MIL On With DTC(s) P060694 and/or P060647

Applicability

YEAR(S)	MODEL(S)	ADDITIONAL INFORMATION
2023	Sequoia HV	
2022 - 2023	Tundra HV

REVISION NOTICE

Figure 1. Location of Authorized Modifications Label on 2022 – 2023 Tundra HV and 2023 Sequoia HV

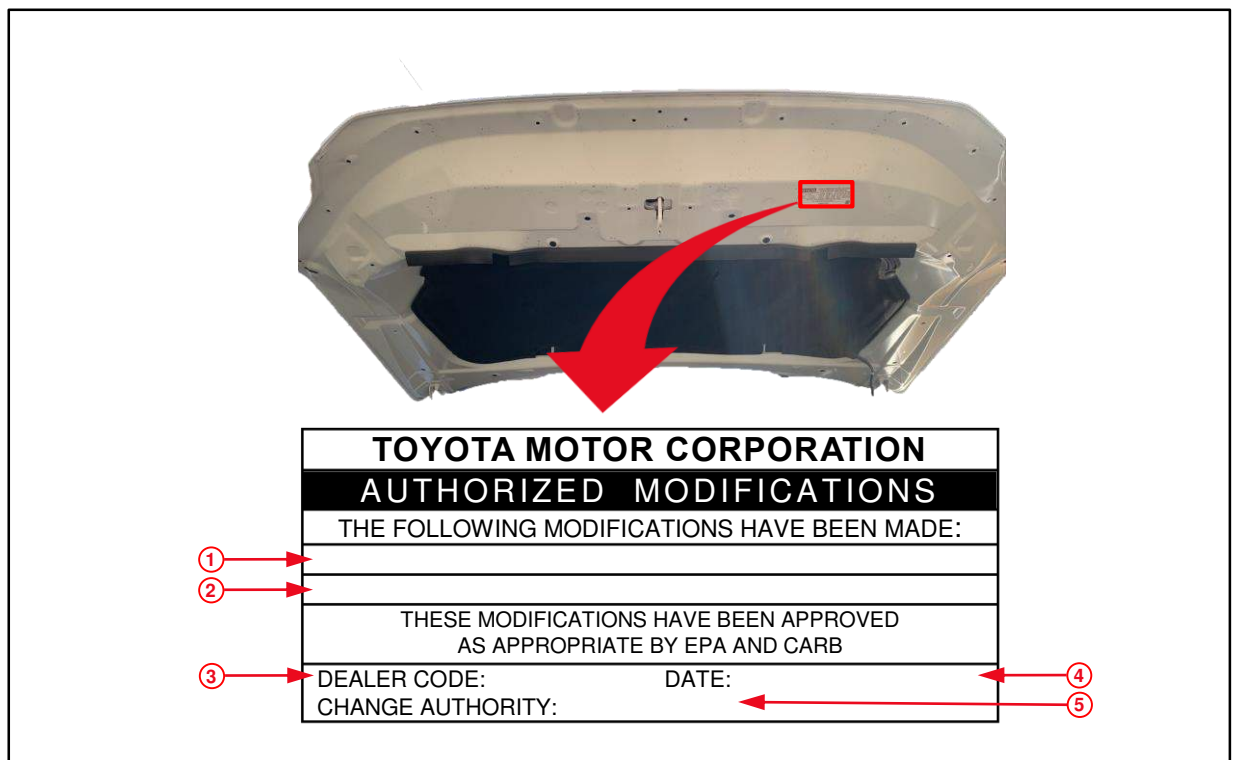
2. Use Techstream to confirm if the ECM (PCM) calibration has been updated and check for the Authorized Modifications Label affixed to the vehicle in the location shown below.
Is the calibration ID listed in Techstream and on the label the latest ECM (PCM) calibration?
 - **YES** — This bulletin does NOT apply. Continue diagnosis using the applicable Repair Manual.
 - **NO** — Continue to step 3.

4. Prepare and install the Authorized Modifications Label.
 - A. Using a permanent marker, enter the following information on the label:
 - ECM (PCM) part number [*Refer to the **Parts Information** section for the **NEW PART NUMBER***]
 - Calibration ID(s) [*Refer to the **Calibration Information** section for the **NEW CALIBRATION ID***]
 - Dealer Code
 - Repair Date
 - Change Authority [***This bulletin number***]
 - B. Install the Authorized Modifications Label onto the vehicle at the location shown in Figure 1. The Authorized Modifications Label is available through the MDC, P/N 00451-00001-LBL.
5. Test-drive the vehicle to confirm proper operation.
